**ADDENDUM NO. 1**

PROJECT NAME: **2017-2018 TASK ORDER CONTRACT FOR FLATWORK AND STREET IMPROVEMENTS PACKAGE 19**

**– 23-01472-05-03**

DATE: 9/09/2016

### SAW CUT AT CURB LINE

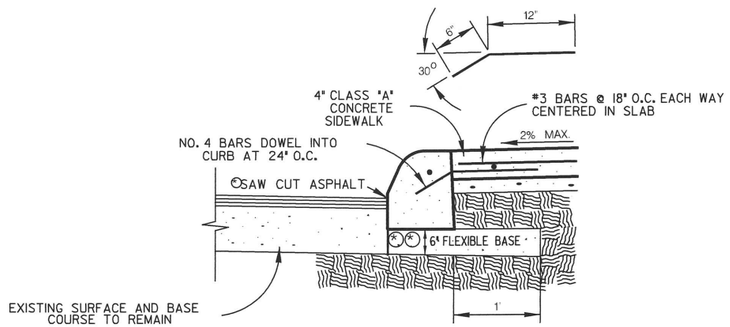
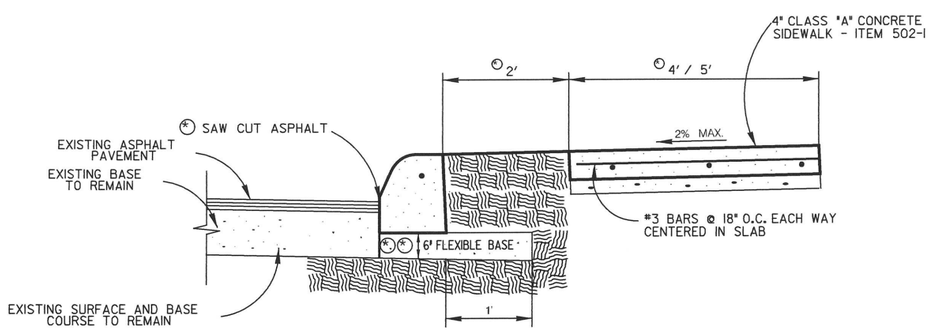
(*) NO DIRECT PAYMENT SHALL BE MADE FOR SAW CUTTING, TRENCHING, EXCAVATION, & FLEXIBLE BASE, FOR CONSTRUCTION OF CURB. ALL COST IN CONNECTION THEREWITH SHALL BE INCLUDED WITH THE UNIT PRICE OF CURB RAMPS AND CONCRETE CURB. ENGINEER OR PROJECT MANAGER TO MAKE FINAL DETERMINATION IF ASPHALT REPAIRS ARE REQUIRED, AND THE LIMITS OF THE REPAIR.

(**) IF EXISTING ACCEPTABLE BASE IS PRESENT UNDERNEATH PROPOSED CURB ALIGNMENT, THEN CURB MAY BE PLACED WITHOUT THE ADDITION OF NEW BASE. IF NO BASE IS PRESENT UNDERNEATH PROPOSED CURB, THEN A MINIMUM OF 6" FLEXIBLE BASE MUST BE INSTALLED DIRECTLY UNDERNEATH AND FOR A DISTANCE 1' BEHIND CURB. ALL COST INCURRED SHALL BE INCLUDED IN THE UNIT COST OF CONCRETE CURB.

THESE DETAILS SHALL GOVERN THE LIMITS OF ASPHALT REPAIR AND BASE INSTALLATION ASSOCIATED WITH CONCRETE CURB FOR FLATWORK ONLY PROJECTS. FOR PROJECTS THAT REQUIRE PAVEMENT WIDENING, CONTRACTOR SHALL FOLLOW DETAILS OUTLINED IN MISCELLANEOUS CONSTRUCTION STANDARDS I. REGARDLESS OF APPLICATION, THE UNIT PRICE FOR CURB SHALL INCLUDE 1' OF 2" TYPE D HMAP.

### SAW CUT 12" IN FRONT OF CURB LINE

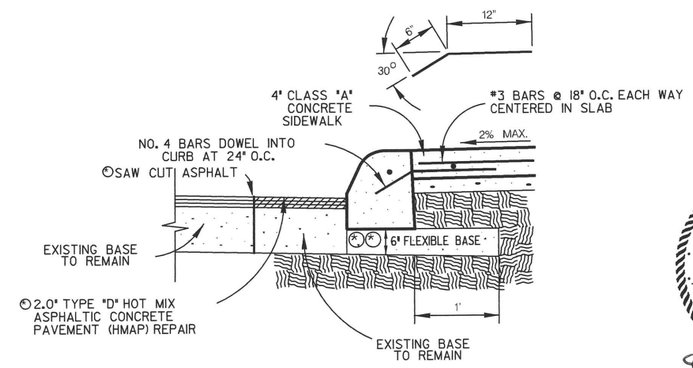
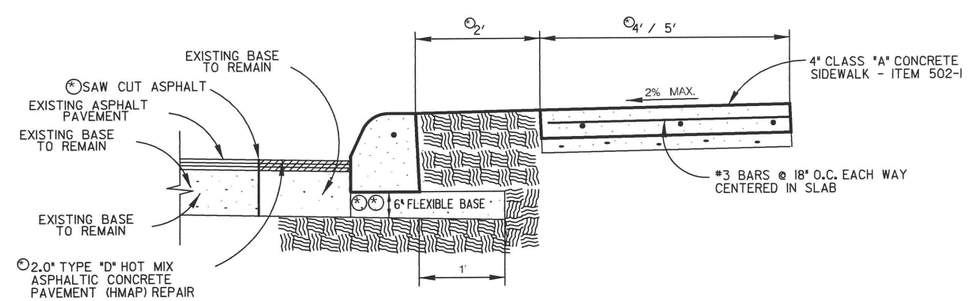
(*) NO DIRECT PAYMENT SHALL BE MADE FOR SAW CUTTING, TRENCHING FOR CONSTRUCTION OF CURB, EXCAVATION, ASPHALT REPAIR TO INCLUDE TACK COAT, AND FLEXIBLE BASE WITHIN 1' OF FACE OF CURB. ALL COST IN CONNECTION THEREWITH SHALL BE INCLUDED WITH THE UNIT PRICE OF CURB RAMPS AND CONCRETE CURB. ENGINEER OR PROJECT MANAGER TO MAKE FINAL DETERMINATION ON LIMITS OF ASPHALT REPAIR.

(**) IF EXISTING ACCEPTABLE BASE IS PRESENT UNDERNEATH PROPOSED CURB ALIGNMENT, THEN CURB MAY BE PLACED WITHOUT THE ADDITION OF NEW BASE. IF NO BASE IS PRESENT UNDERNEATH PROPOSED CURB, THEN A MINIMUM OF 6" FLEXIBLE BASE MUST BE INSTALLED DIRECTLY UNDERNEATH AND FOR A DISTANCE 1' BEHIND CURB. ALL COST INCURRED SHALL BE INCLUDED IN THE UNIT COST OF CONCRETE CURB.
